# **NS Power IRP**

# Comments received from Participants in response to Draft Findings, Action Plan and Roadmap

# September 2020

Figure 1: Build-out of additional Wind Capacity in the initial Scenarios.

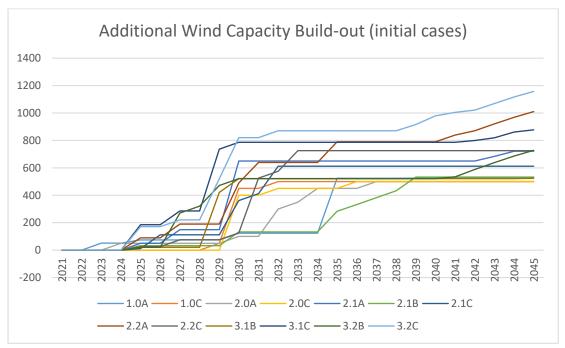
As can be observed, several scenarios have approximately 200 MW of new wind capacity coming on by 2025 to 2027, and amounts ranging from 400 to 800 MW by 2029/2030. The higher wind capacities are generally arising in the cases based on higher electrification, as might be expected.

Figure 2: Build-out of additional Wind Capacity in the initial Scenarios.

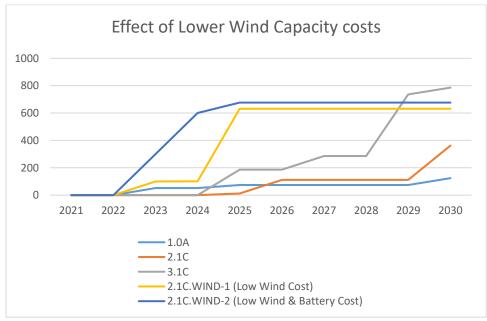
As can be seen, the lower wind costs have a profound effect on the resource build out plan, even compared to the "original" scenarios with higher wind build-out (such as Case 3.1C). Much larger
